April 16, 2019

Subject: Response to Site Investigation Summary and Remedial Action Report for
Barb & Ron's Cleaners (Former), 1700 S. Lawe St., Appleton, WI
DNR BRRTS # 02-45-297744

Figure 2, *Site Layout and Sample Location Map*, by EnviroForensics, 1/9/18

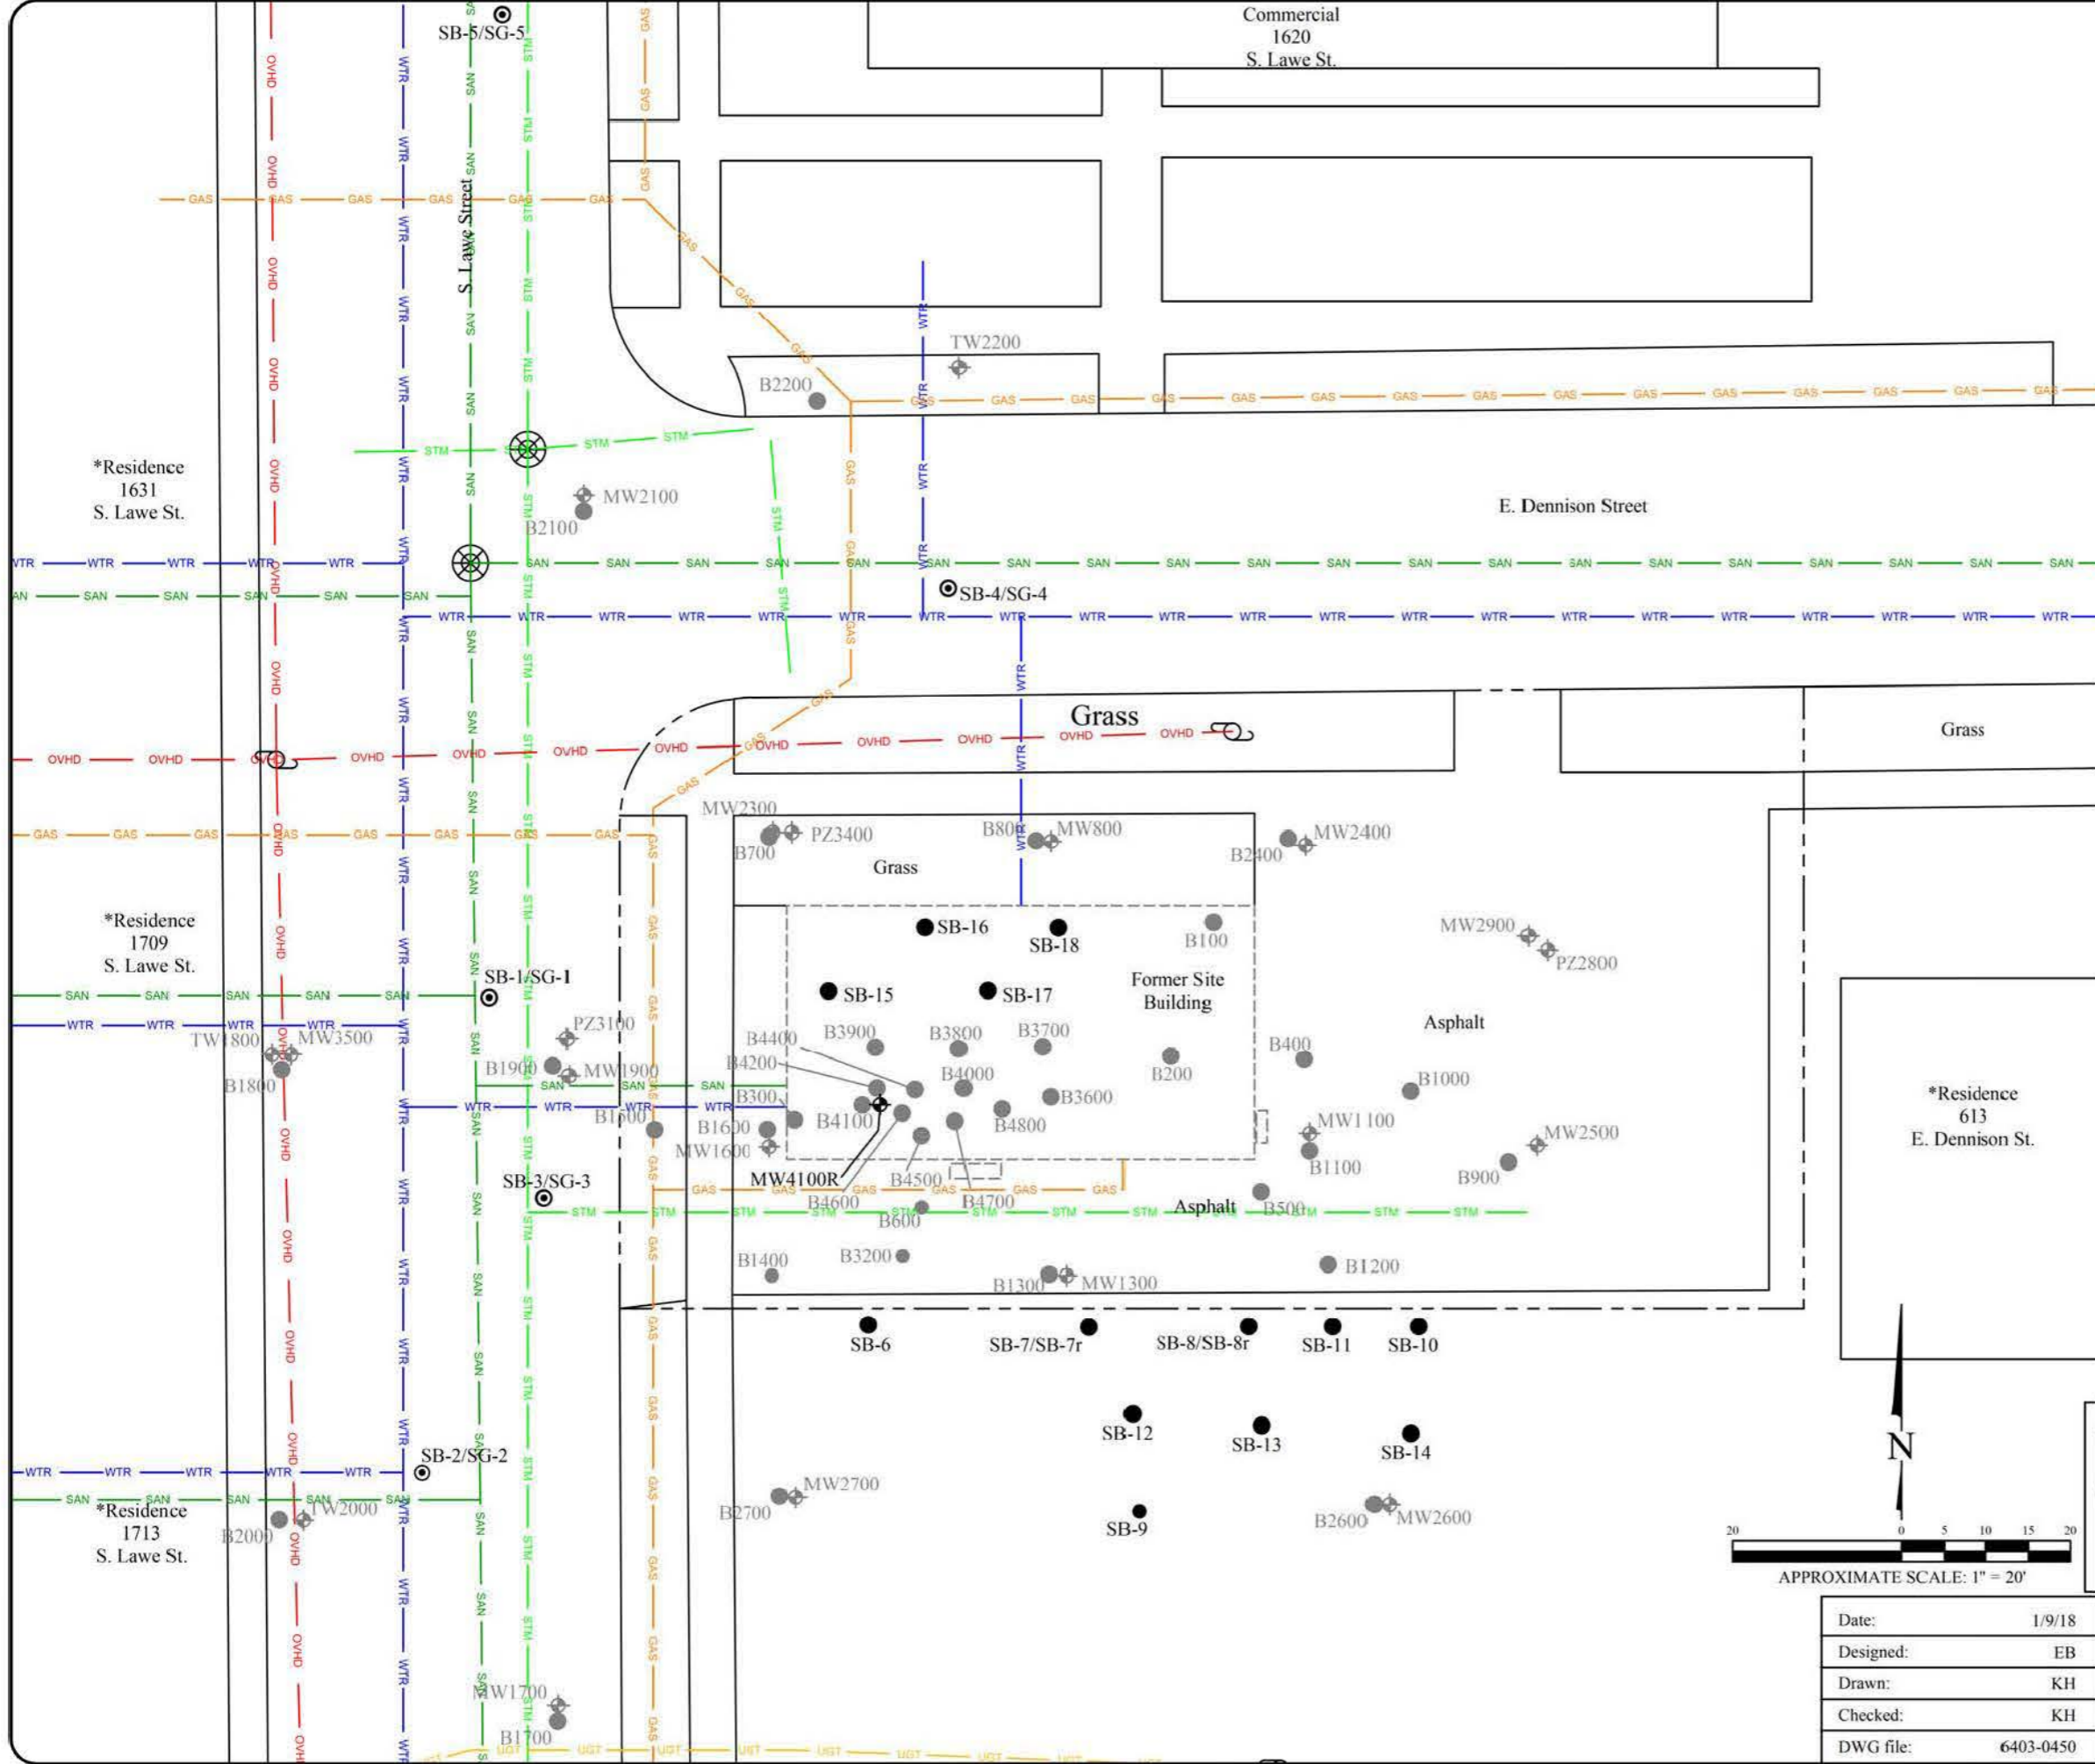
The extent of soil contamination in South Lawe Street is not yet defined. Soil samples should be collected within the backfill of the storm and sanitary sewer mains at 0-2 ft bgs and 6-8 ft bgs in the following three locations:

1. North of SB-1 but south of East Dennison Street;
2. West of B1900/B1500; and
3. South of SB-3 but north of SB-2.

Based on DNR review of the SI/RA Report, the extent of soil is defined to the east, southeast and south. Soil to the north is relatively defined. No additional soil investigation to the north is needed if the extent of soil contamination is inferred into East Dennison Street. Alternatively, additional soil investigation can be performed to determine if the limits of soil contamination extend into East Dennison Street.

The vertical extent of groundwater contamination is not yet defined as required in Wis. Admin. Code § NR 716.11(3)(a). A piezometer nested with monitoring well, MW4100R, or slightly adjacent, is needed to define the vertical extent of residual groundwater contamination. The piezometer may need to be double-cased depending on soil data to prevent drawdown of contamination.

A groundwater sample at the location of the former soil boring, SB-5, in South Lawe Street needs to be collected and analyzed for CVOCs to confirm the March 2016 exceedance of the preventive action limit (PAL) for tetrachloroethylene (PCE). If the enforcement standard is exceeded, additional investigation will be necessary.

Additional information and likely vapor investigation are needed to fully investigate vapor intrusion from preferential pathways (i.e., sewers) based on data from SG-4, SG-5 and the vapor data obtained from 1631, 1709 and 1713 South Lawe Street. A discussion of the remedial actions performed along and adjacent to the sewers, the status of the historical sewer laterals and upgrades to utility mains along with a conceptual site model should be presented to specifically address the concern for migration of vapors within the utility pipes from the source area(s) to neighboring residences.

It is also unclear if a historical sanitary or storm sewer lateral was present on the north side of the Property adjacent to the water lateral and should be researched as well. Specifically, the vapor data from SG-4 within East Dennison Street needs further evaluation as the vapor data does not appear to correspond with soil or groundwater data.

Additional information needs to be included on maps for future evaluation of data or the vapor pathway:

- The residential building footprints for 1623, 1631, 1709 and 1713 South Lawe Street;
- Sanitary, storm and water laterals for the listed residences;
- Note on maps that there is an active radon mitigation system at 1631 South Lawe Street and the month/year it was verified as being operated;
- Indicate where wells have been destroyed or abandoned;
- Cross sections should clarify that "clay fill" was used to backfill the excavation beneath the building; and
- If applicable, historical laterals should also be added to the maps.
